RFI ID	258		
То	John Frenkel	From	Will Butler
	JC Commercial, Inc.		Page Southerland Page, Inc.
	1801 Lakepointe Drive		1800 Main Street
	Suite 129		Suite 123
	Lewisville TX 75057		Dallas TX 75201
	United States		United States
	(972) 436-4622		(469) 621 4837
Project	417151 - City of Addison Airport	Project No.	417151
Date	4/29/2021	Transmittal ID	01301
Subject	P#51R1 Cantilever Gate in Place of V		
	Track		
We are sending	☐ Attached	Via	Info Exchange
•	☐ Under Separate Cover		- -

Project:	Addison Airport Gustoms and		Customer	TOWITOL AUGISON			
	Border Protection Facility			5350 Beltline Road			
Date:	8/18/2020			Dallas, Texas 75254			
Attn:	Jeff Mechlem, Mitchell McAnally		Architect	Page Southerland Page			
	Will Butler, Vlad Stevanovic			1100 Louisiana Street, Suite	One		
	·			Houston, Texas 77002			
This Prop	osal contains an itemized quotation for changes in the	Contract Sum an	d/or Contrac	t Time in response to proposed			
	ions to the Contract Documents based on RFI #039

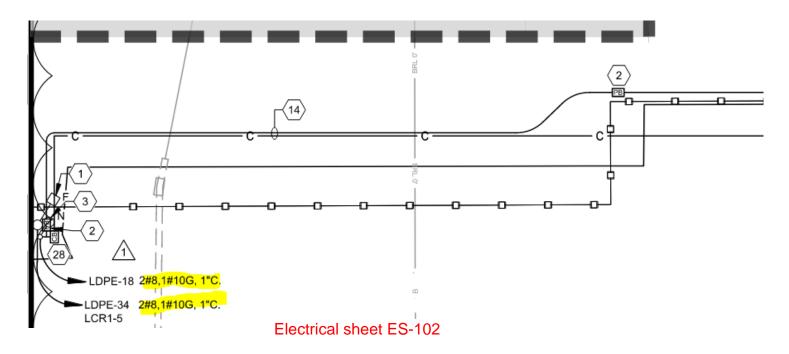
Contractor to revise proposed credit as indicated above as it appears to cover only 2 sets of 1" conduits for electrical. Proposed credit does not account for the following:

- Does not account for (2) sets of 2" conduits for data as shown on sheet T-100 and note 9
- Eliminating (1) set of pull box for data as shown on sheet T-100 and note 8
- Does not account for eliminating length for (2) sets of 2#8,1#10G copper branch circuits
- Does not account for eliminating length for (2) data cables

Contractor to itemize each item for the credit proposed in the revised price proposal.

Sheet C-204 calls for 37-foot, 7-foot ornamental steel fence - as indicated below.

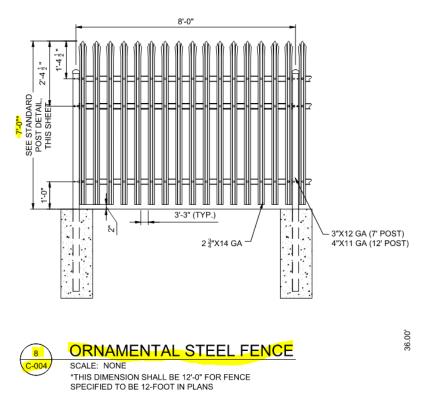
Contractor to revise proposed credit to include correct fence length and type of fencing. Refer below for construction documents and unit list pricing from JC Commercial:

Per the project contract documents JC-Commercial shall provide a credit of the unit price of the removed line items associated with the ornamental fence behind the generator as detailed above, totaling \$4,677.75.

A-211 Interior Elevations (179% of Scale); Takeoff in Active Area: All Areas; Bullet Resistent; JCS 2019 Q1; 11/6/2020 06:45 AM

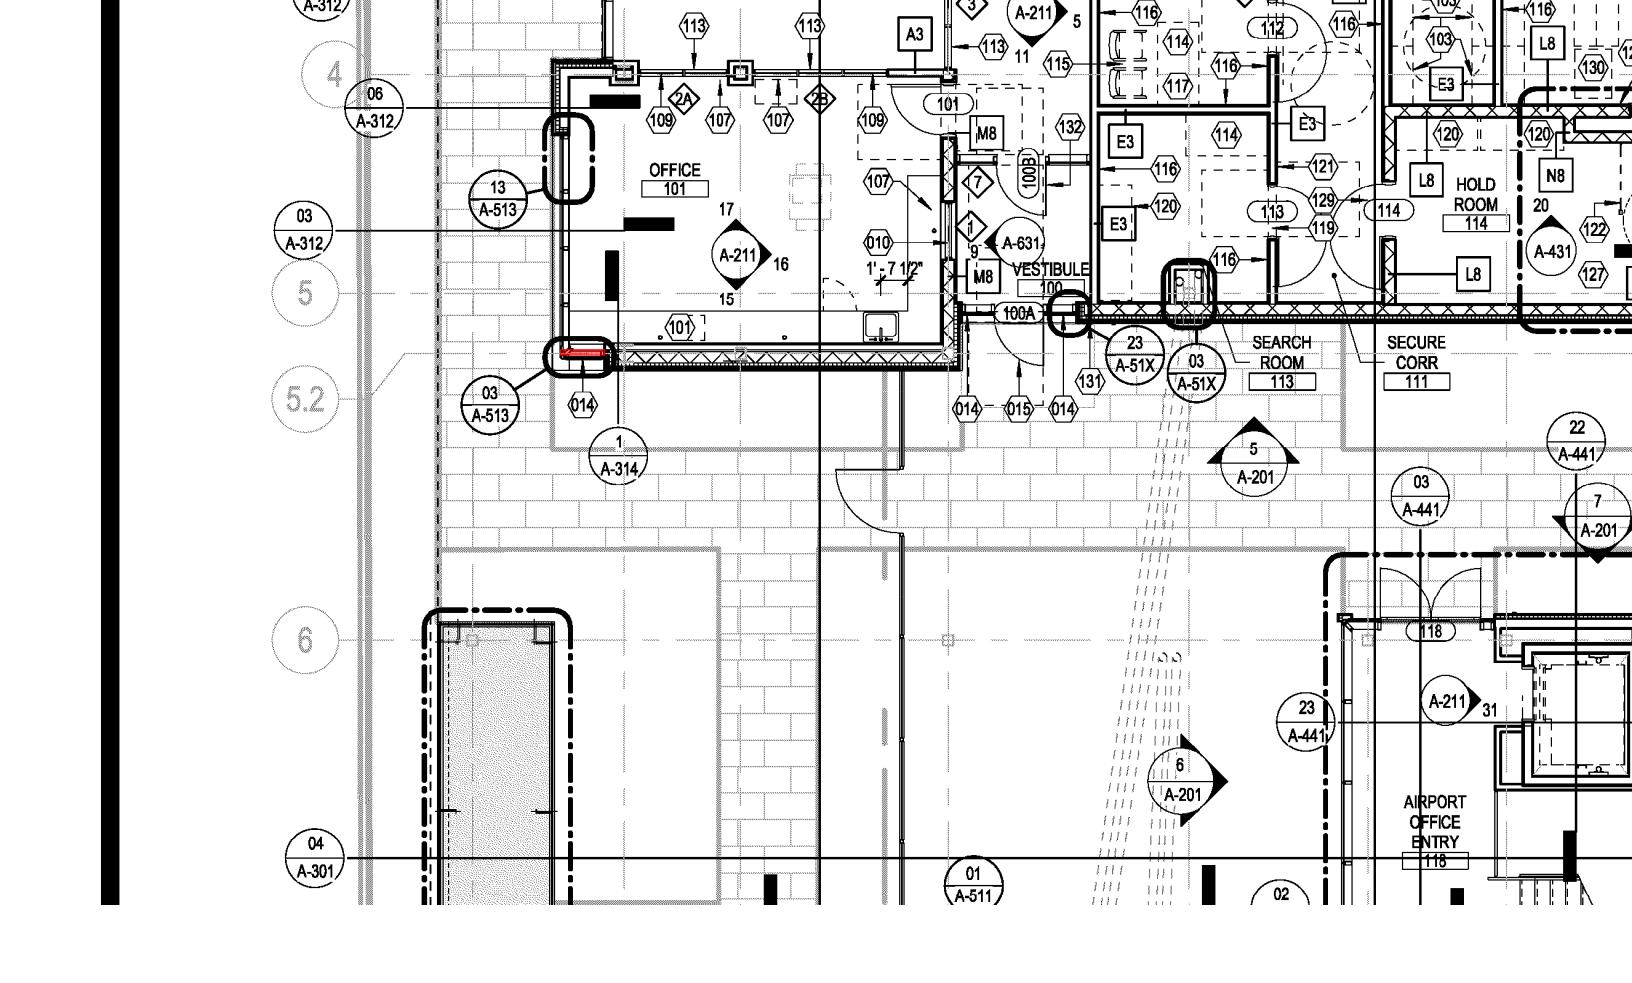
GC to review and double check the costs associated with this RFI. The added area of bullet resistant paneling roughly doubled but the cost appears to have risen by more than 2x. Please confirm and justify the large jump in cost between this proposal and the previous version. See attached exhibit provided in response to Proposal #49 showing the approximate area added.

SIGNAGE SCHEDULE

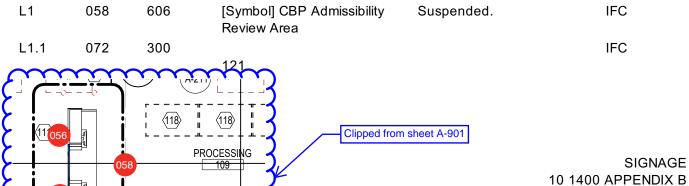
According to the attached schedule (attached) we are to furnish 1 each 004 sign and 1 each 006 sign at a cost of \$3,017.00 each. The sign Elevation plans also only show 1 each location for the CBP 004 and 006 signs (attached). The actual cost quoted to JC is \$3,326.00. Proposal #67 is attached to reflect the material cost for one additional sign as well as (2X) the difference between the bid price of \$3,017.00 and the currently provided price of \$3,326.00.

I have attached an email chain from DHS where on March 12, they refer to modifications to the signs. Can you please confirm these modifications have been applied and confirm that there will not be any charges over the amount of \$3,326.00

Signs 054 & 056 are indicated in the signage plan (Sheet A-901) and the message schedule in the specifications (see page 4 of 9 for the page from the specifications). These signs are limited to just the 15" diameter DHS seal as noted in the provided message schedule and specifications. These seals are meant to be installed on the free standing millowork desk located in Processing 109. Per the included signage schedule (page 5 of 9), these signs/seals are to be provided by CBP so no additional cost is owed to the GC for these signs/seals.

GC to revise and resubmit the proposal to include only the \$618.00 difference in cost between the specified value of Sign 004 and Sign 006 when compared to the actual cost as provided by the CBP signage vendor. No additional cost are required to provide signs 054 and 056 since they are furnished by CBP. If need be, the Architect or CBP staff will install them on the millwork desk using the provided double sided tape that they will come with. Total value of the revised proposal should be \$618.00 + GC mark-up only.

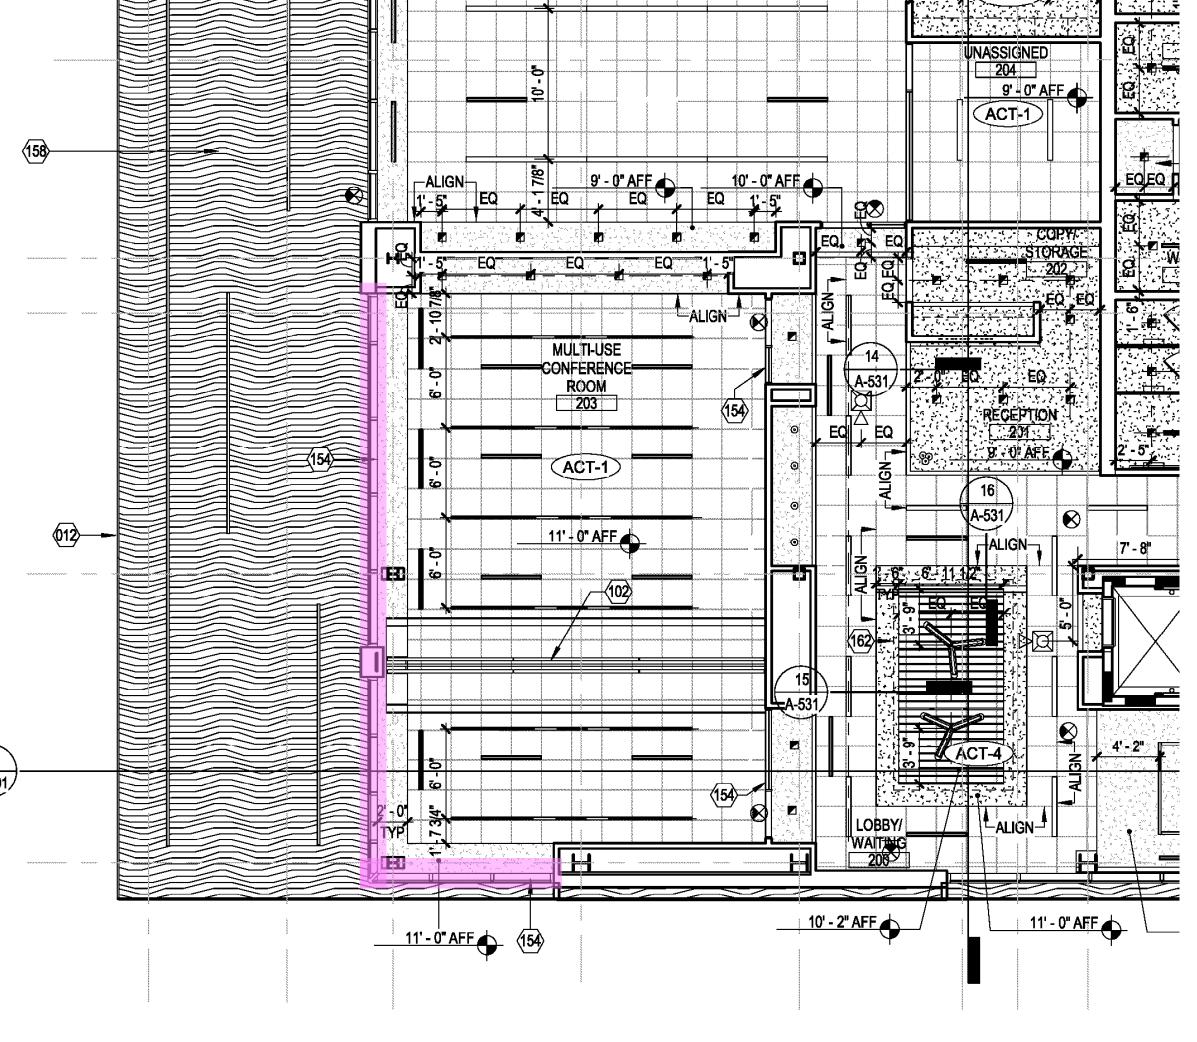
Proposal #62 attached for adjustments to the furrdown for double shades in room 203(the multi use conference room. Detail 3 on Page A-501 shows a 5" pocket in this area, however an 8" pocket is required for double mecho roller shades.
